TECHNICAL SERVICES BULLETIN

TSB number: 824CQ35329
 FA number: FA-US-2025-0002
 Bulletin Title: VF8_Drivers Front Seat Centre Airbag Replacement
 Released by: VF - Aftersales Operation
 Date of issue: 10 Feb 2025
 Applies to: VF Aftersales, Dealers and Showrooms

Figure 1

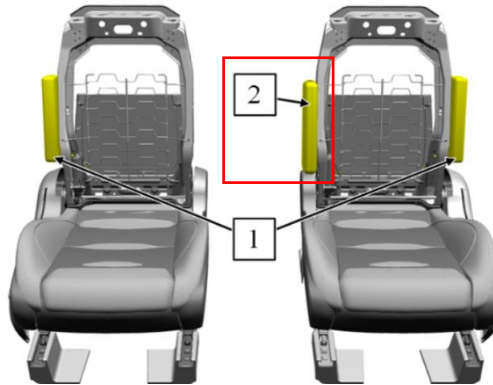
1. Replace the drivers front seat inboard centre airbag (**Item 2** – Figure 1), refer to the Service Instruction procedure [Front Seat Back Airbag \(Inboard or Outboard\) Removal and Installation/Replacement – 1003789](#).

- Please collect serial numbers of old and new parts for warranty claim.
- Replace with new nuts STD20000075 (x2).
